**Comment Response Document (CRD)
to Notice of Proposed Amendment (NPA) 21-2005**

**on Certification Specifications, including airworthiness codes and acceptable
means of compliance, for Large Aeroplanes (CS-25)**

**“FUEL TANK STRUCTURAL INTEGRITY / FUEL TANK ACCESS
COVERS”**

Figure a: Transmission of pressure from a fuel tank outside the fuselage and a fuel tank inside the fuselage (example with a forward load case)

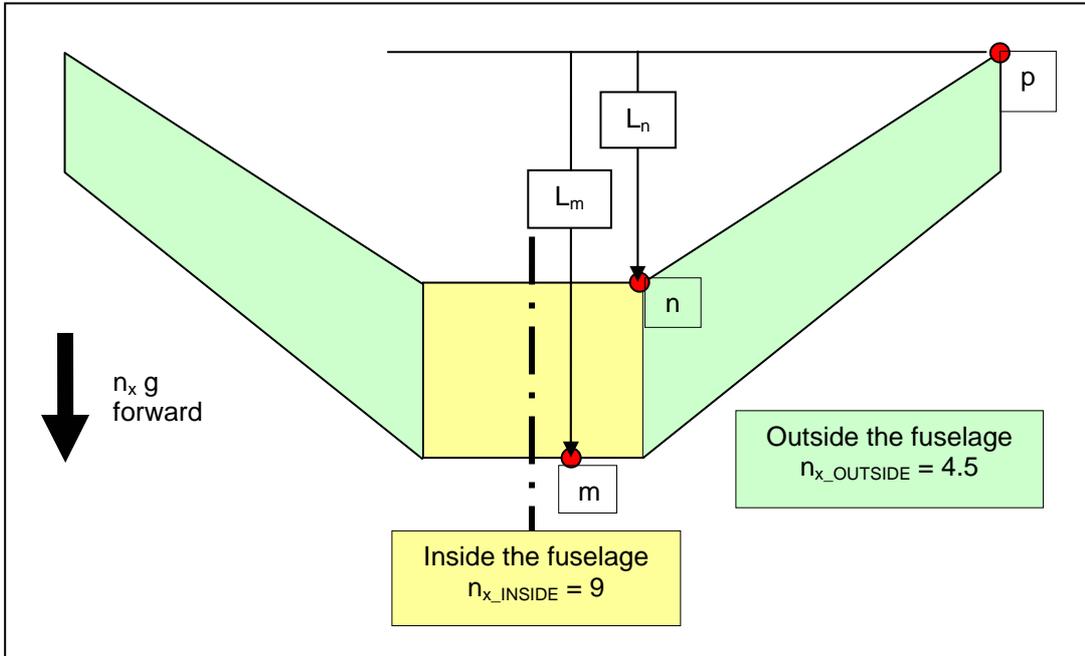
| Com-ment # | Para | Commentor | Comment/Justification | Response | Resulting text |
|------------|------|-----------|---|----------|----------------|
| | | | <p>not be designed to withstand 9g but a lower factor.</p> <p>2. A second approach is to consider the inside and outside tanks as independent from a hydrostatic point of view and to sum the pressures in each fuel tank by</p> <ul style="list-style-type: none"> a. considering a conservative interface point for the transmission of the pressure (choice of the point “n” on the figure (a)), b. defining for each fuel tank the length L, and, c. applying to each fuel tank the relevant K. <p>As a conclusion of the above choice and in order to clarify the intent of the rule, one of the following options shall be chosen and be added in AMC 25.963(d), at the end of paragraph 4 a:</p> <p>Option A: <i>QUOTE:</i> If the barrier between a fuel tank inside the fuselage and a fuel tank outside the fuselage cannot be considered as a solid barrier, then the pressure is transmitted from the outside fuel tank to the inside one. Therefore, the two fuel tanks should be considered as a unique one in the definition of the ultimate hydrostatic design conditions for the inside fuselage. <i>ENDQUOTE.</i></p> <p>Option B: <i>QUOTE:</i> If the barrier between a fuel tank inside the fuselage and a fuel tank outside the fuselage cannot be considered as a solid barrier, then the pressure is transmitted from the outside fuel tank to the inside one. Therefore, the ultimate hydrostatic design conditions for the inside fuselage will be found by defining a conservative frontier between the two tanks and from this frontier, compute the pressure in the inside fuel tank by adding the impact of the pressure</p> | | |

| Com-ment # | Para | Commentor | Comment/Justification | Response | Resulting text |
|------------|------------------|-----------|--|---|-----------------|
| | | | <p>in the outside fuel tank, taking into account the respective L and K for each fuel tank. The figure (a) illustrates this approach and the formula below:</p> $\text{pressure}(m) = \rho.g * n_{\text{OUTSIDE}} * L_n + \rho.g * n_{\text{INSIDE}} * (L_m - L_n)$ <p>[Figure (a) moved to Appendix 1]</p> <p><i>ENDQUOTE</i></p> | | |

| Com-ment # | Para | Commentor | Comment/Justification | Response | Resulting text |
|------------|--|-------------|--|---|---|
| 2. | Draft Decision Proposal 5 - AMC25.963(d) Chapter 4, paragraph (a) titled <i>Fuel tank pressure loads</i> | DGAC France | <p>A) Split paragraph a) into two paragraphs by adding a “(b)” at the beginning of the sentence starting “any internal barriers to free flow...” within the paragraph (a). Consequently renumber current paragraphs (b) to (f) into (c) to (g).</p> <p>B) At the end of paragraph (a) (<i>and before the new paragraph b) proposed in A) above</i>), clarify the rule by adding :</p> <ul style="list-style-type: none"> • the QUOTE/ENDQUOTE text proposed in Option A at the end of the following justification <p>or</p> <ul style="list-style-type: none"> • the QUOTE/ENDQUOTE text proposed in Option B at the end of the following justification, | <p>Noted. The specific design case offered for discussion is considered to be sufficiently addressed by the text of 25.963(d) and the associated guidance material, i.e. the text indicates that the first approach (option A) as described in the comment should be taken. Therefore there is no need to amend the text as proposed. If a different means of compliance is being applied to a specific certification program this may become subject of a Certification Review Item (CRI)</p> | No text change. |
